Battle Creek Salmon and Steelhead Restoration Project

Initial Response to the Technical Review Panel Report

FIGURE 2

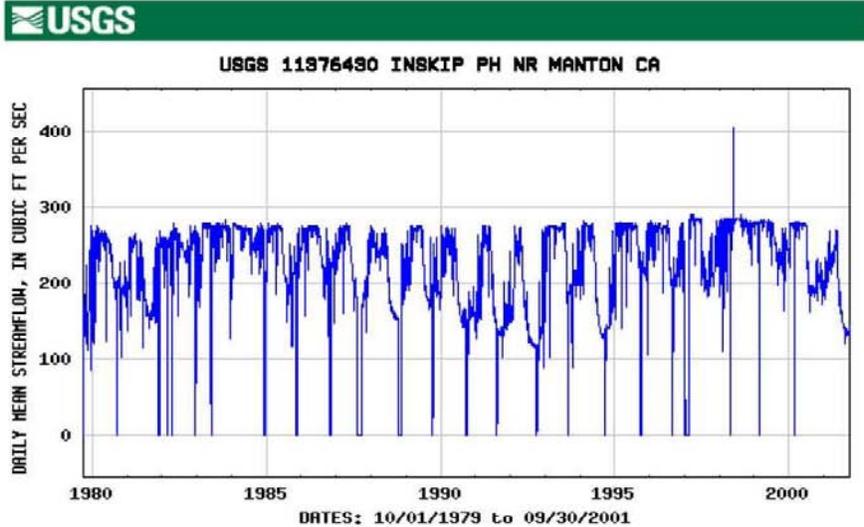
***Comment - a:** For a few days each spring, and for periodic maintenance of the turbines, the steel high-pressure penstock that supplies water to the powerhouse will be shut down for maintenance. Currently no facility exists to divert water from the Inskip Canal. For reasons not fully disclosed in the Conceptual Design Report, the project includes a bypass structure to bypass water when the penstock is shut down. At least 11 alternatives were reviewed including a “do nothing” alternative. The “do nothing” alternative was considered too severe because of economic and environmental concerns. However, considering the overall cost of the bypass facility, the economics may not be completely justified. The cost of the structure appears to be approximately \$1.5 million (actual construction costs were impossible to determine because costs were not delineated by element of the project), or about 6% of the total construction budget. Less cost might be incurred by simply paying for the lost power production due to the infrequent outages associated with maintaining the facility.*

Comment - b: The Preliminary Technical Report indicates the orifice size in the fish ladder has been changed from 15 inches to 24 inches. It did not indicate why the change was made. It should be confirmed that this would not adversely affect the performance of the ladder. The report indicates this ladder design was selected for its previous performance, but does not indicate what effect this change might make.

PMT Response: An overflow wasteway currently exists on the Inskip Canal to release bypass flows directly to the South Fork in the event of an emergency shutdown of Inskip Powerhouse. This structure is to be modified by the addition of stop planks, as shown on drawing OA-60-96, to prevent future operation. The proposed replacement bypass facility, or penstock bypass, is currently estimated to cost approximately \$4.3 million, rather than the \$1.5 million indicated in the Technical Panel Review Report.

The proposed Inskip Powerhouse Bypass is a necessary component of the Restoration Project to fulfill the need of maintaining reliable production of fish and energy, as developed in the MOU. The frequency and magnitude of the need for the bypass structure is illustrated in the hydrograph shown in Figure 2. The hydrograph illustrates the planned and unplanned outages as powerhouse discharge going to zero. These discharges may occur at unpredictable times. During planned outages and especially during unplanned outages, water flowing in the canal towards the powerhouse once a shutdown has occurred will have to be released around the powerhouse. Environmental damage from an uncontrolled release of water would be the certain result without some form of bypass structure intact.

PMT Response: A larger orifice was proposed for this fish ladder because the design team wanted the fish ladder to have a total capacity of approximately 39 cfs. 40 cfs is PG&E’s minimum instream flow requirement for the months May through November. The design team wanted at least the minimum flow requirement of 40 cfs to pass entirely in the fish ladder. A standard half ice harbor with 15 inch orifices has an approximate total capacity of 29 cfs with one foot of head. To make the capacity of the ladder able to handle the 40 cfs minimum flow at one foot of head, the orifice size was increased to 24 inches. With this configuration, there is approximately 22.5 cfs flowing through the orifice and 16.5 cfs flowing over the weir section for a total ladder capacity of 39 cfs.

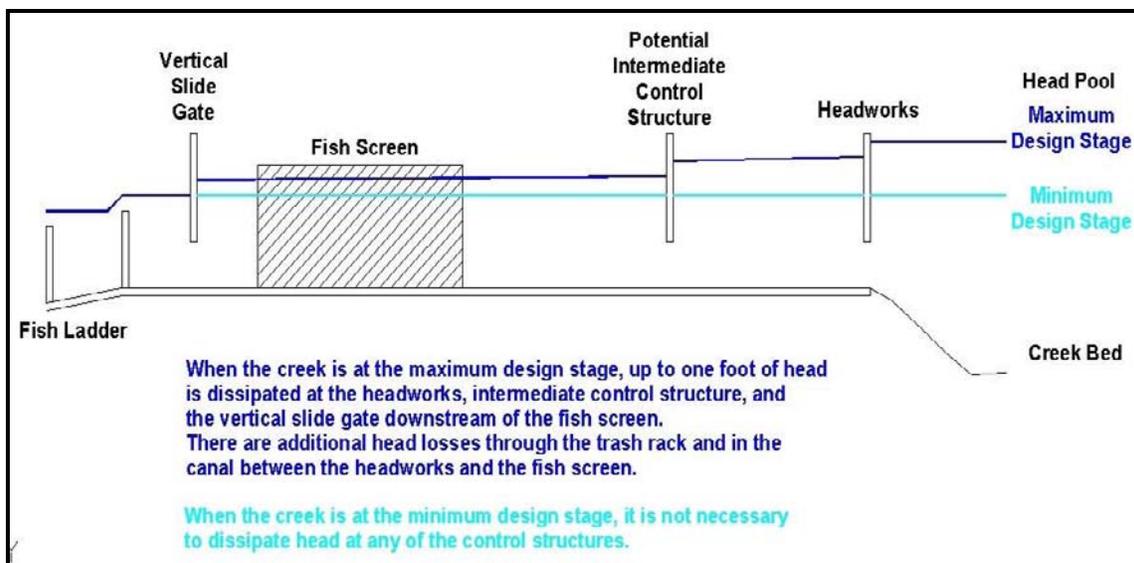
Abbreviated Comment - d: Throttling several feet of head with entrance gates may not provide appropriate fish passage conditions.

PMT Response: This is a very technically complex part of the fishway design. The fish team spent several meetings discussing the expected dissipation of head throughout this section of the fishway. The fishway is designed to always meet the accepted criteria of having one-foot head drop or less through a control structure. It was never the plan to dissipate more than one foot of head with any individual structure.

In the preliminary engineering report the maximum design condition was a 4.5 foot change in water surface elevations between the top pool of the fish ladder and the creek upstream of the headwork's. Calculation were performed for each structure and are summarized:

- 0.2 feet of head would be dissipated by the trash rack (this was neglected).
- One foot of head would be dissipated by the headgates.
- One foot of head would be dissipated by the roughness of the tunnel
- 0.5 foot of head would be dissipated by the sediment trap
- One foot of head would be dissipated by the intermediate control structure (if required).

These calculations show that at the maximum design conditions, no more than one foot of head is dissipated at any one structure.

During the final design process a new hydraulic analysis was performed. This new analysis showed that with a concrete lined canal where the tunnel used to be, there would be about one foot less head dissipated than there would be for the unlined canal proposed in the preliminary design. For this reason the final designers added one step to the fish ladder so that now only 3.5 feet of head needs to be dissipated. It should be noted that as a cost saving measure, the plan has been to not initially install the hardware necessary to dissipate a full foot of head at the intermediate control structure. Based on the available hydrology and hydraulics, it was determined that a condition where there was a 3.5 foot head differential would rarely, if ever, occur during the operational range of the fish ladder. If it is determined that this condition occurs while fish are migrating upstream, then gates will be added to the intermediate control structure most likely as part of the adaptive management program.

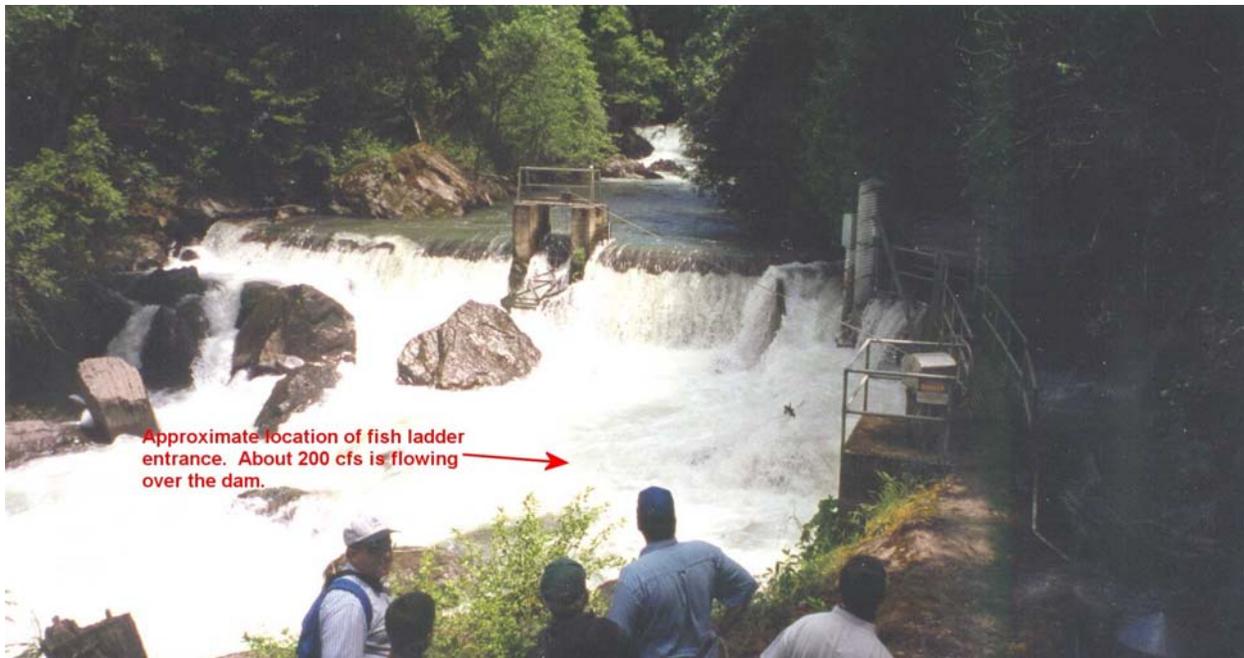
Abbreviated Comment – e: There are provisions for video counting adults in the ladder. Discussions indicated that the fish would be crowded to the surface to facilitate counting, but the plans did not show this feature. This should be reviewed.

PMT Response: The counting station will be located at the upstream baffle in the fish ladder. The counting apparatus will likely be a series of cameras attached to brackets on the upstream side of this baffle and they will record fish passing upstream through it. During final design, other configurations, including the crowding of fish, were investigated but were abandoned

because of their potential for accumulating debris and because many areas contain turbulent water that may make it difficult to see fish. Since electronic technology advances rapidly, and since there are often several years between the concept phase and when construction occurs, the Ladder & Screen Technical Team decided during final design to not specify the exact camera type or configuration in the contract. The decision was to install the cameras via notice of change during construction or to install them separately after construction. The video monitoring details at Eagle Canyon are shown on drawings OA-60-369 and 370. To clarify the drawings, the locations of the video monitoring will be added to appropriate fish ladder plan views.

Figure 1. Conceptual model of channel response following dam removal in Battle Creek.

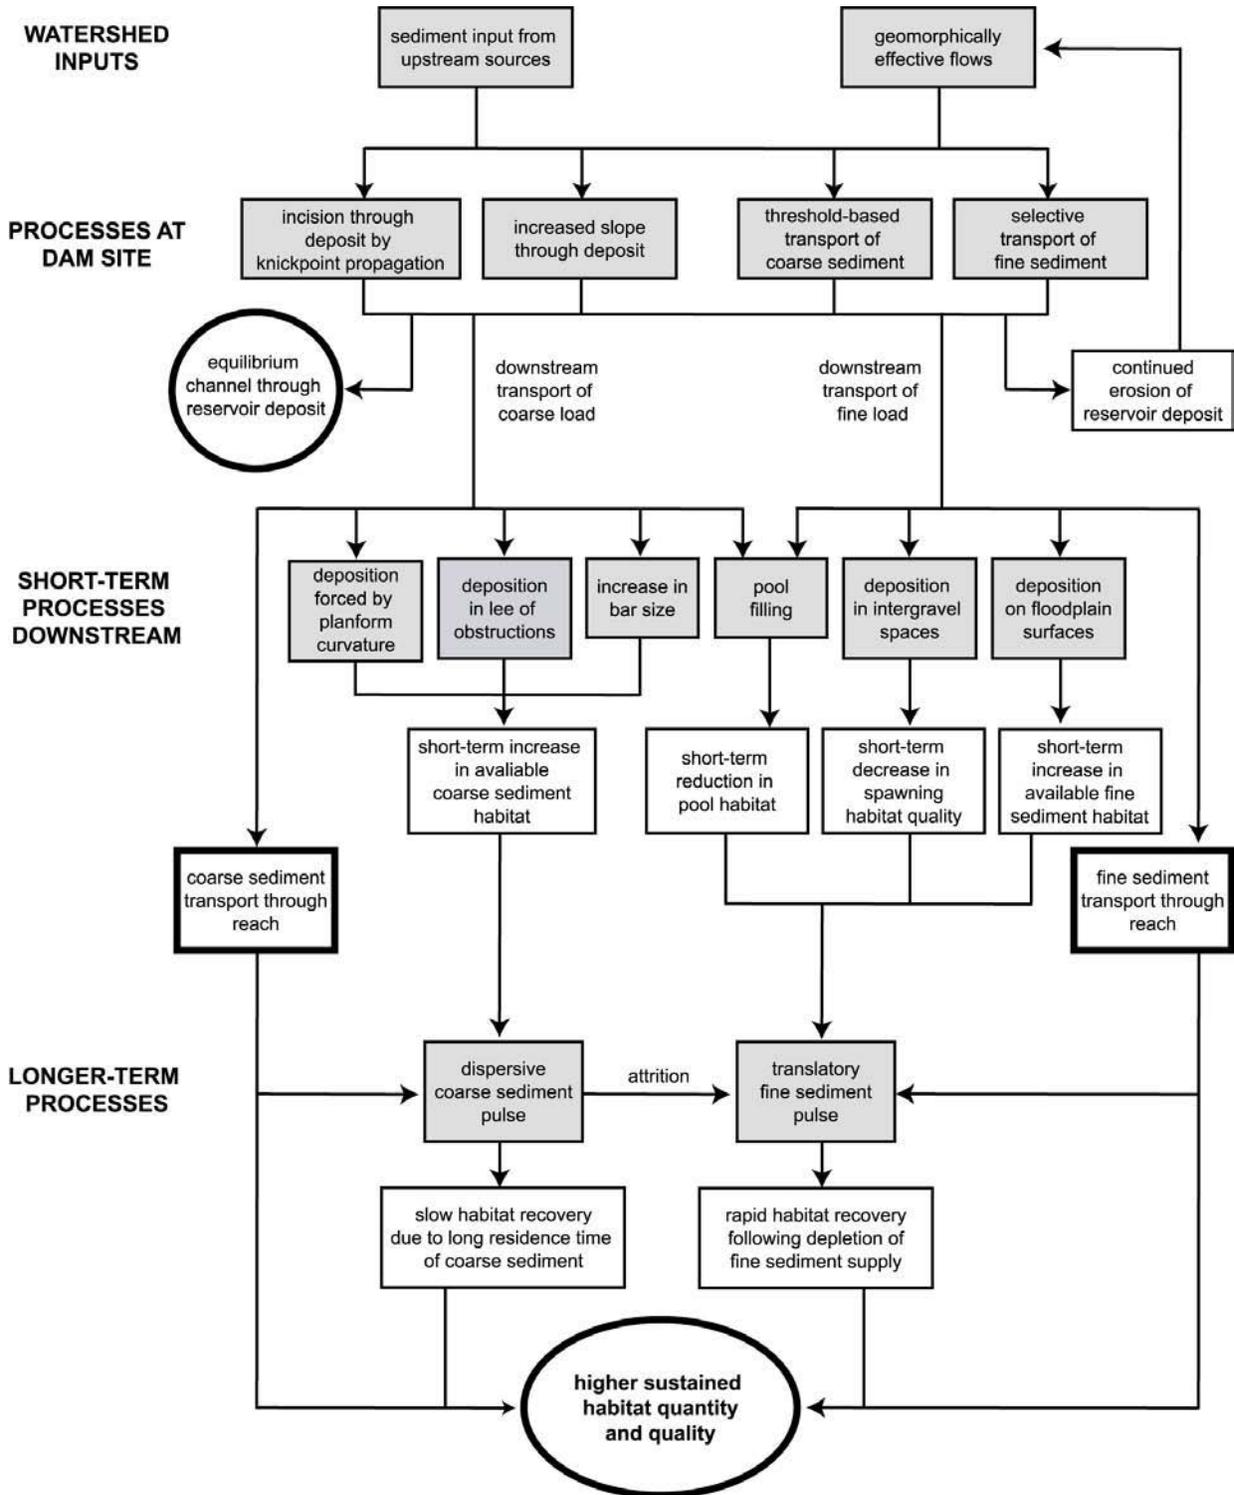
Abbreviated Comment – a: As an alternative to allowing sediment erode immediately and possibly cause downstream fisheries impacts, sediment could be excavated and temporarily placed on embankments at an elevation that would allow it to be mobilized only in flood events that would mobilize spawning material. Placing angular pieces of the masonry dam also presents possible short-term conflicts for fish passage and spawning in this critical reach for winter-run Chinook salmon.

Previous studies on sediment waves or pulses indicate that a pile of coarse grained sediment in a river evolves by dispersion rather than translation (e.g., Lisle et al. 1997, 2001; Cui et al. 2003a,b; Cui and Parker, in press). Numerical studies on dam removal in steep gradient rivers indicate that, in addition to the general dispersive behavior, sediment deposition downstream of the dam occurs only at reaches of low sediment transport capacity (e.g., Stillwater Sciences, 2000; Cui and Wilcox, in press; Cui et al. in press [a,b]). We believe the depositional characteristics following the removal of the dams on the Battle Creek will be similar. Due to the small amount of sediment in the reservoirs, however, the deposition will be in a much small scale and amplitude, and the deposition will most likely be in the existing pools.

The conceptual model for sediment response following dam removal on Battle Creek (Figure 1) is, therefore, driven by the increase in slope at the face of the stored sediment wedge following dam removal. Sediment is eroded from the face of the stored sediment (either on a 'process' or 'event' driven basis) causing incision by knickpoint propagation and channel formation through and potentially upstream of the stored sediment. The eroded sediment will aggrade downstream of the former dam site with finer sediments initially transported further downstream. These effects may result in reduced pool volume, fining of gravel substrates, and increased aerial extent of gravel bars. The dynamics of aggradation will depend on whether the released sediment acts as a stationary store of material that disperses over greater and greater distance through time or a translating pulse of material with limited attenuation downstream (more likely in fine-grained sediments). It is possible that habitat-related impact will depend on which of these modes of transport dominates: translation will create significant short-term habitat changes as the sediment pulse passes, whereas dispersal may cause a less substantial but longer lasting impact due to longer sediment residence time. In steep-gradient channels, downstream sediment deposition will not be evenly distributed and may be confined to pools, the lee of boulder and bedrock flow obstructions, bars forced by planform curvature, lower-gradient channel segments, and floodplain surfaces. Some component of the finer fraction of coarse-grained sediments will deposit in pools following flow events. The length of time require to reach an equilibrium channel condition (if applicable) is a function of the sediment grain size distribution, stored sediment volume available for transport, channel gradient, and frequency of bed-mobilizing flow events. Both the form of the equilibrium channel condition and the time required to reach equilibrium following sediment release are unknown. The downstream extend and duration of the 'short-term' impact of sediment release on aquatic habitat is similarly unknown.
